Notice of Allowability

10/707,501

EXAMINER'S AMENDMENT

FIG. 1C

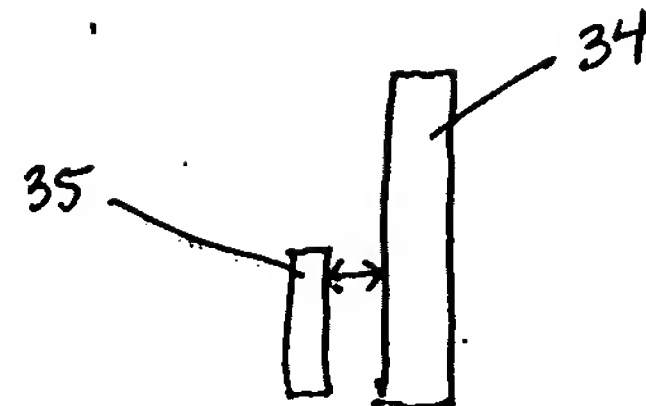
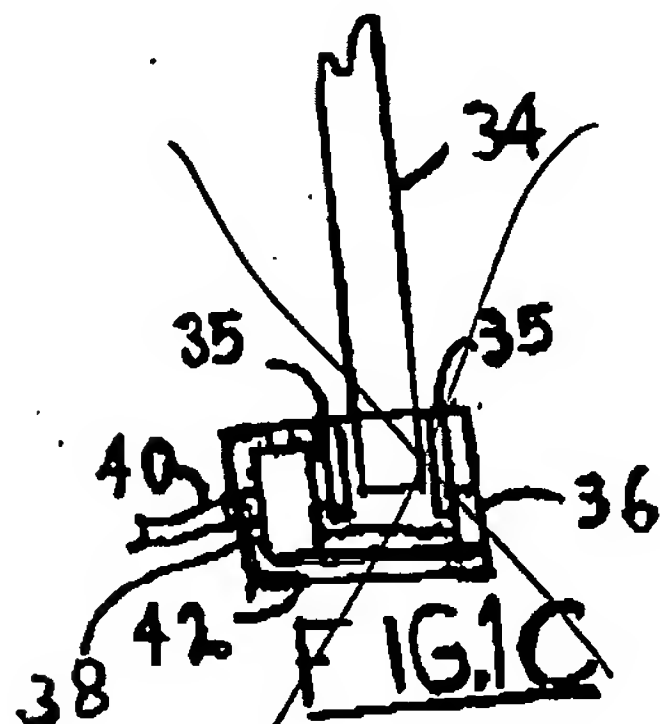
2. The following changes to the drawings have been approved by the examiner and agreed upon by applicant: figures 1A-1C have been revised as shown in the accompanying marked up version of the drawings to include the different placements of the friction component 35 with respect to the wheel rotor to avoid new matter issues. In order to avoid abandonment of the application, applicant must make these above agreed upon drawing changes.
